ORIGINATION FORM

Proposed Revisions to a Standard Plans Index

Index Number: 430-022

Index Title: Side Drain Mitered End Section

SIDEDRAIN MITERED END SECTION
(Concrete Pipe Shown, Corrugated Metal Pipe Similar)

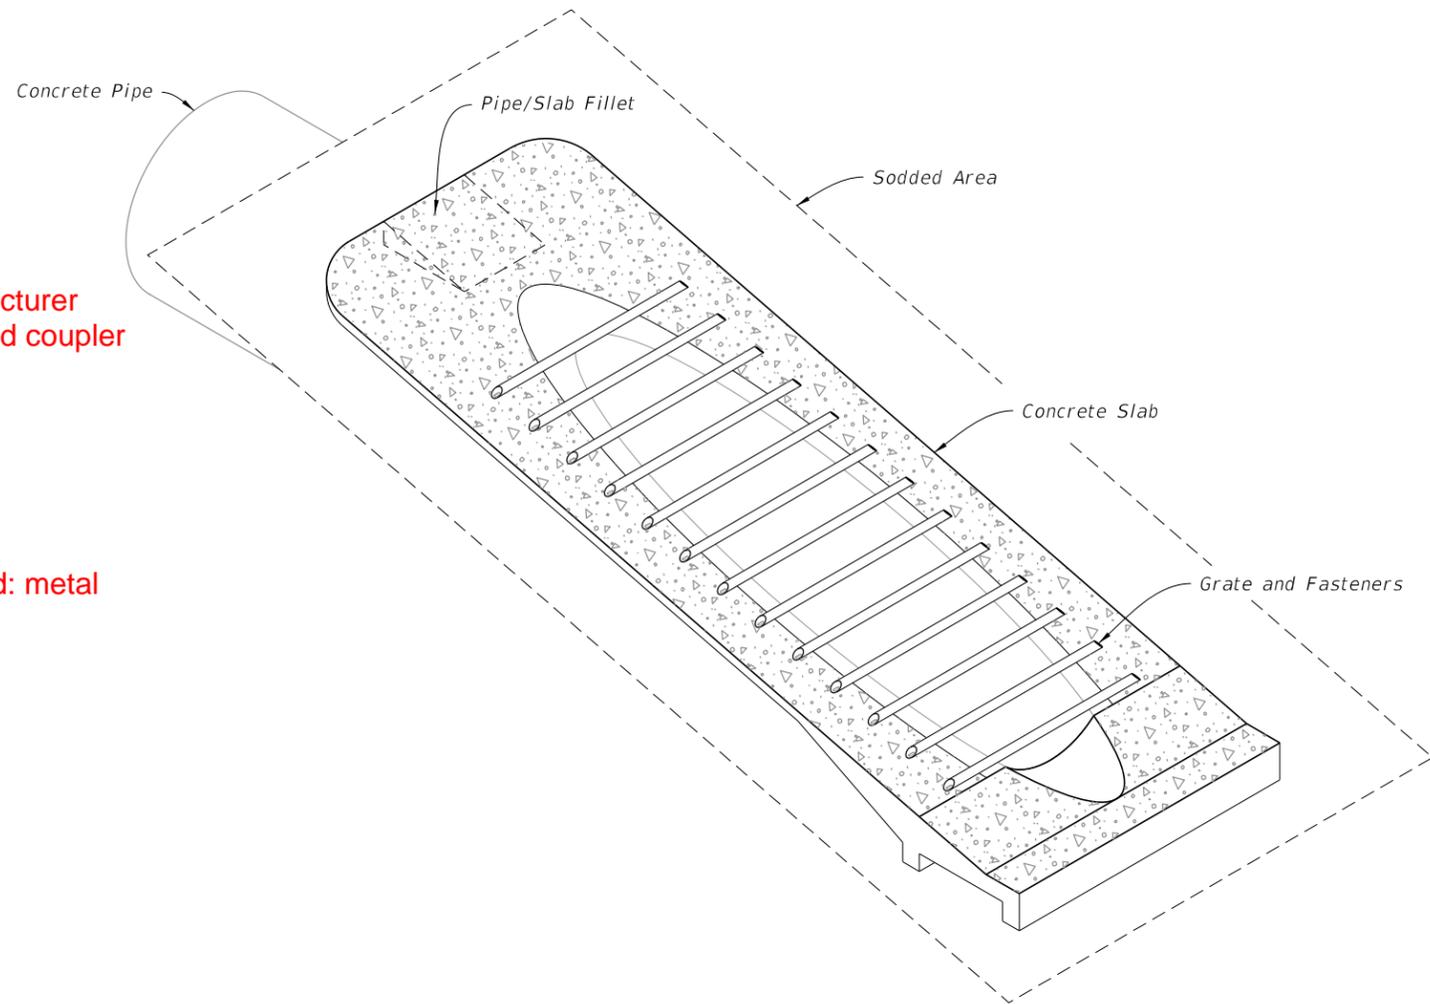
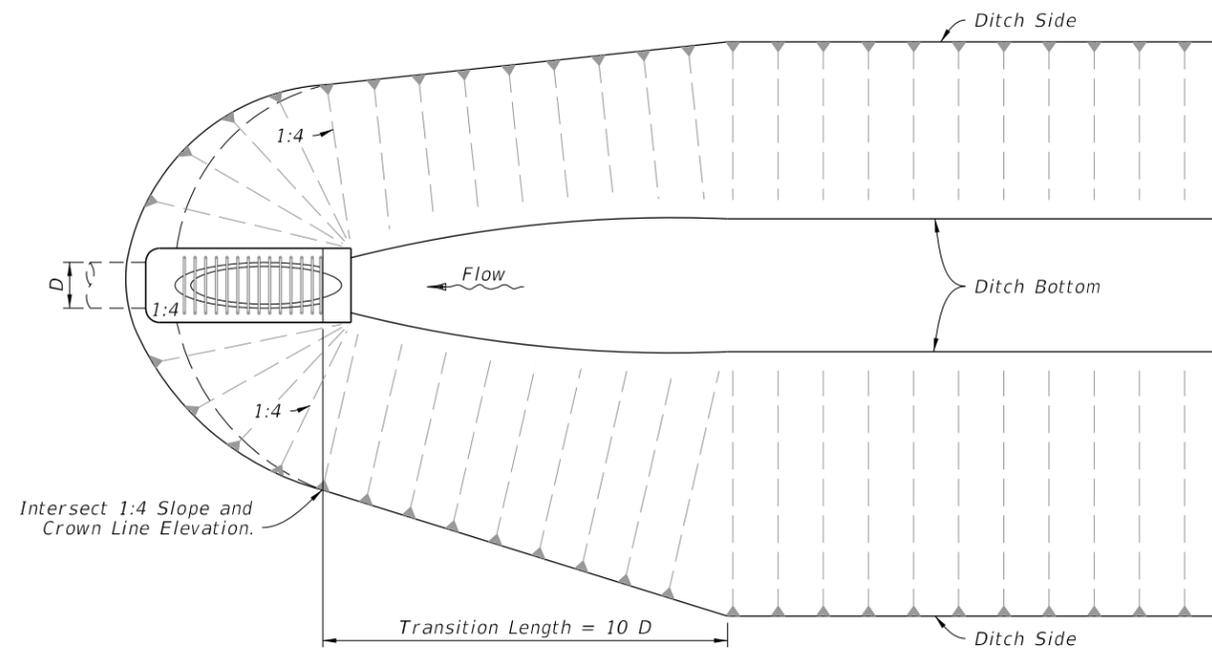
General Note 1: Added "or use manufacturer approved coupler" on the end

General Note 2: Added "metal" between corrugated and mitered. Delete "either."

or use manufacturer approved coupler

Deleted

Added: metal

Added "or use a manufacturer approved coupler" to General Note 1 for situations where concrete jacket is not used.

Deleted "either" from General Note 2 because it was left over from a previous edition. Added "metal" to specify material.
